EVALUATION OF EMERGENCY RESPONSE FACILITIES FOR  
INDIAN POINT - UNIT 2

October 1981

Pacific Northwest Laboratory  
Richland, Washington 99352

FIGURE 2.1

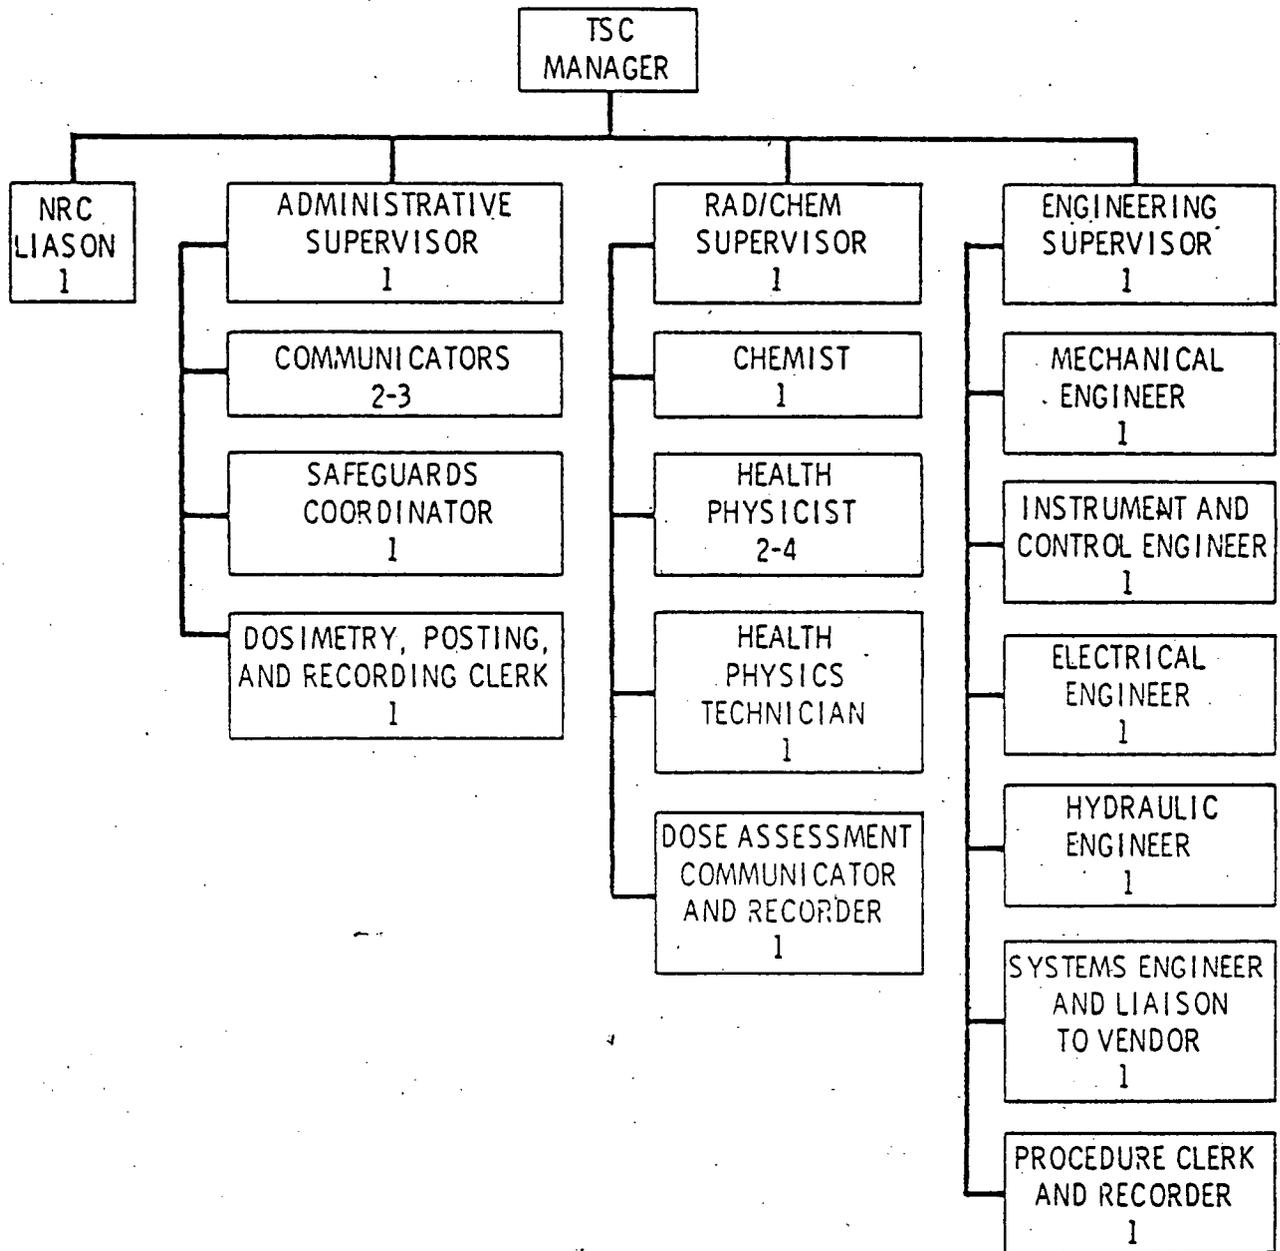
<p>Describe the organization of the work stations. Are they organized according to Figure 2.1?</p>	<p>Subject not addressed.</p>
<p>Describe how the workspaces are designed to control traffic and noise (mechanical and conversational).</p>	<p>Subject not addressed.</p>
<p>b. Space for TSC data system equipment needed to transmit data to other locations.</p>	<p>Inadequate response. Licensee states this will be true but provided no information for evaluation.</p>
<p>Where is the data displayed?</p>	<p>Subject not addressed.</p>
<p>Show how layouts of displays are coordinated with working space layouts.</p>	<p>Subject not addressed.</p>

- b. Consist of sufficient technical personnel needed to support the control room including individuals who can handle situations involving operations, maintenance, administration, security, Rad/chem, and communications (Figure 2.1 is an example only).

Insufficient information.

FIGURE 5.2

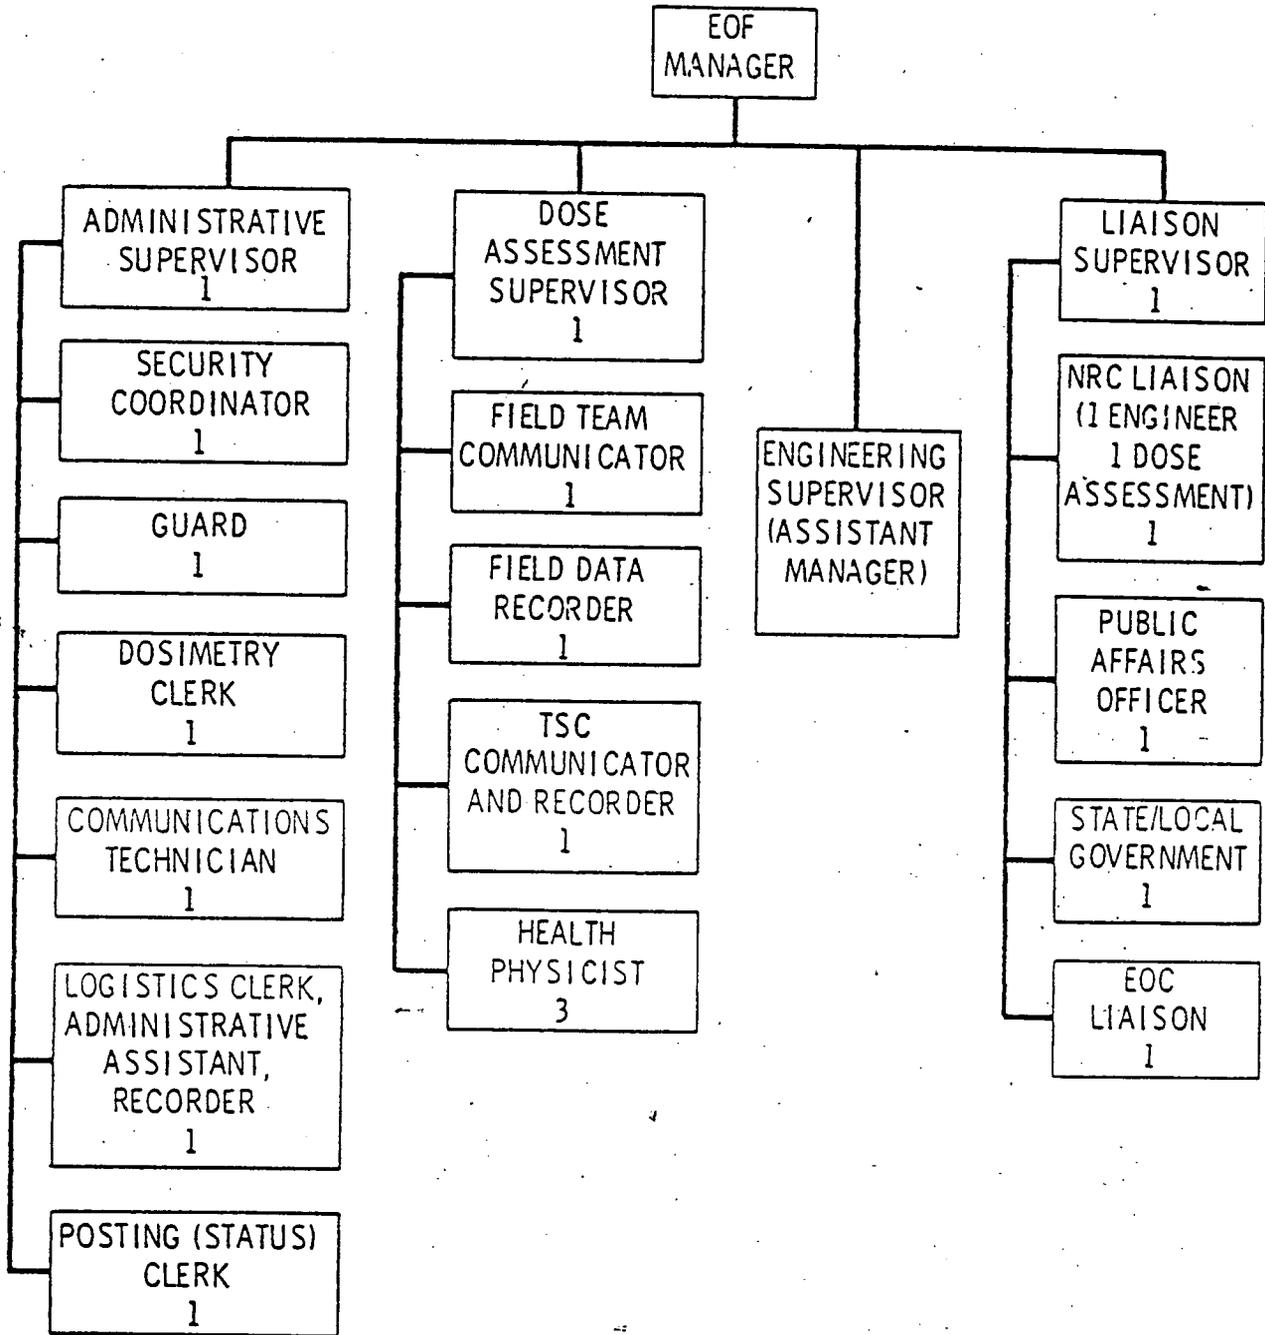
| <p>Describe the organizations of the work stations. Are they organized according to Figure 5.2?</p>  | <p>Subject not addressed.</p>   |
